**IMPERIAL METALS CORPORATION
MT. POLLEY PROJECT**

**RESPONSE TO REVIEW COMMENTS
ON TAILINGS EMBANKMENT DESIGN
(REF. NO. 1625/6)**

JANUARY 25, 1996

IMPERIAL METALS CORPORATION	
MT. POLLEY PROJECT	
TAILINGS STORAGE FACILITY INSTRUMENTATION	
SCALE AS SHOWN	DRG. NO. 510-77-01-1625.220
	REV. 2

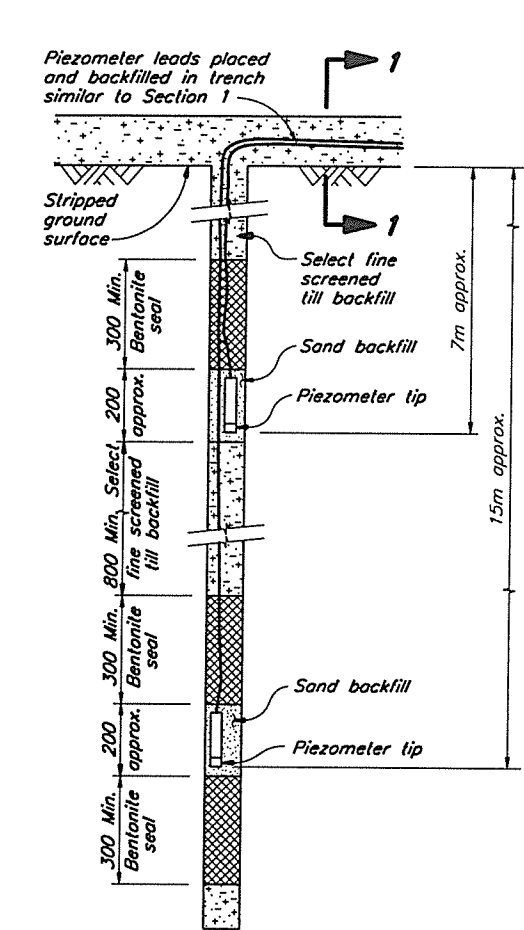
Only one drill hole appears to have been drilled in the main embankment area. In B.C. valleys there is always the possibility of buried high permeability zones. It is recommended that 2 more boreholes to expand the geotechnical information be drilled and tested.

One hole has been drilled in the Main Embankment area (MP89-234), as noted by Mr. Brawner. It has previously been discussed with Mr. Headley (MEMPR) and it was agreed that three additional holes will be drilled, logged and sampled by a geotechnical engineer during the initial stages of construction as part of the embankment instrumentation and monitoring requirements. The holes are specified in

the Technical Specifications and shown on Drawing Nos. 510-77-01-1625.220 and 1625.221. They will be drilled to about 15m depth and will be located in the bottom of the main valley, where significant overburden is known to be present. Lab testing will be conducted on the samples as required and vibrating wire piezometers will be installed in the embankment foundation for long term water pressure monitoring.
